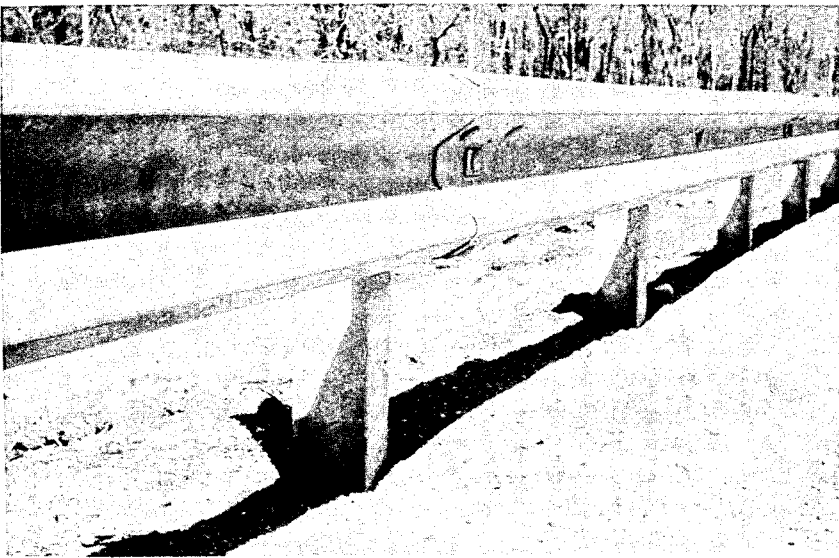
Here is a general view of the same installation, washers all the way through, and this looks pretty good. They have used 6-foot-3-inch spacing on posts.

Here, however, is one thing that we did find, that that 31 inches is up on top of a 6-inch curb for a good bit of the project, and compared to a standard American automobile, you will see that the top of the rail is fairly well up on the car, and I daresay that the possibility of getting into those posts might be a little greater. Just what would happen with respect to the curb in front of the rail on the rail's performance is a little hard to conjecture, but I do not think it would help it.
